Release Notes

MLTG-CN LR

Version: 1.4.3-00335-9d5e29a
Enhanced from version 1.4.2-00287-d6b0c34

1. Operation Mode Modification

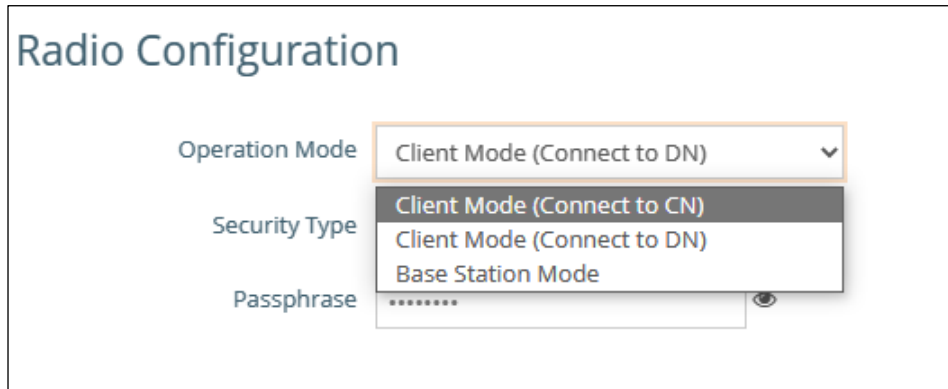
The two types of the client modes are renamed to prevent confusion. Also, it requires to configure the client mode now. When connecting with a DN, please configure it to “Client Mode (Connect to DN)”; when connecting with a base station mode CN, please select “Client Mode (Connect to CN)”.
